RONALD R. BOHANNAN P.E. #7868	AUTOZONE RIO BRAVO SQUARE GRADING AND DRAINAGE PLAN	DRAWN BY EMT DATE 04/07/09 28085-GRE
	 TIERRA WEST, LLC 5571 MIDWAY PARK PLACE NE ALBUQUERQUE, NM 87109 (505)858-3100	SHEET # C2 JOB # 28085

AUTOZONE
RIO BRAVO SQUARE
LANDSCAPE PLAN
TERRA WEST, LLC
5571 MIDWAY PARK PLACE NE
ALBUQUERQUE, NM 87109
(505) 858-3100

ENGINEER'S SEAL	AUTOZONE RIO BRAVO SQUARE	DRAWN BY EMT
	SITE PLAN	DATE 1/15/09
	TERRA WEST, LLC 5571 MIDWAY PARK PLACE NE ALBUQUERQUE, NM 87109 505-310-3100	28085-SPE
RONALD R. BOYER P.E. #7888	RECEIVED HYDROLOGY SECTION	SHEET # C1
		JOB # 28085

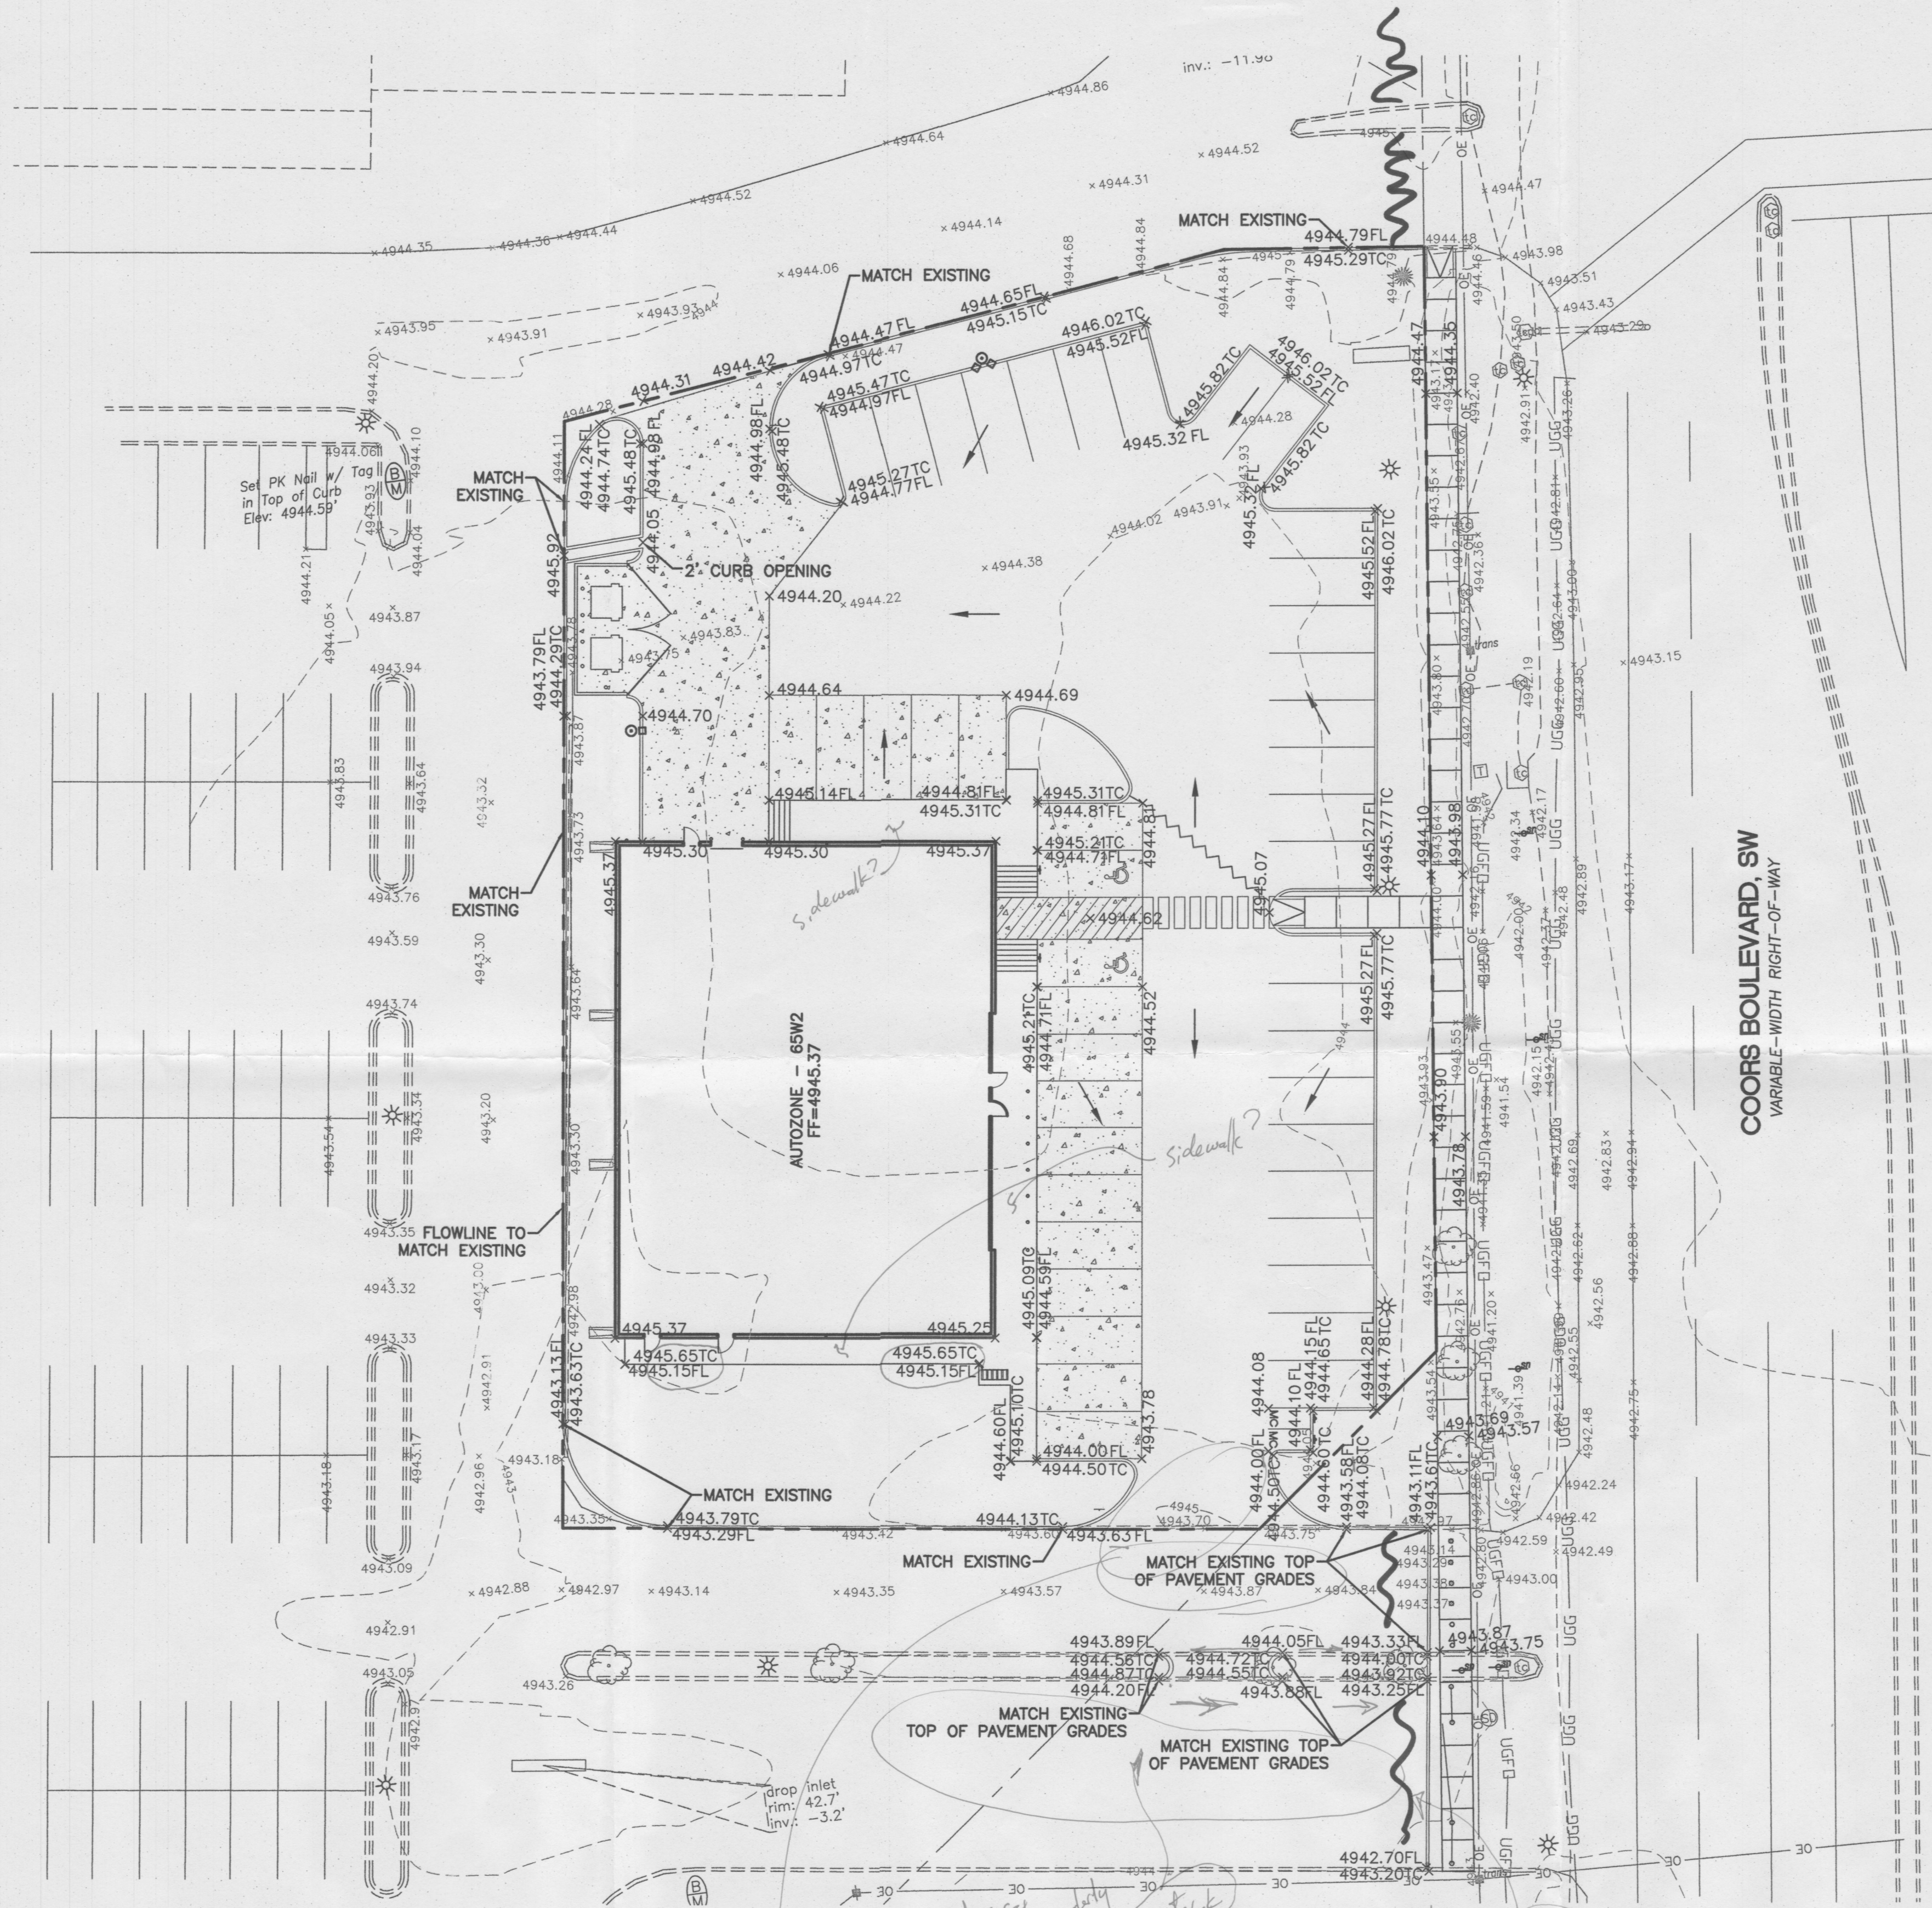
- Section view of 6" Header Curb
- Label Landscape areas - suggest depressing for water harvesting sidewalks?
- Grades High 3.4' High
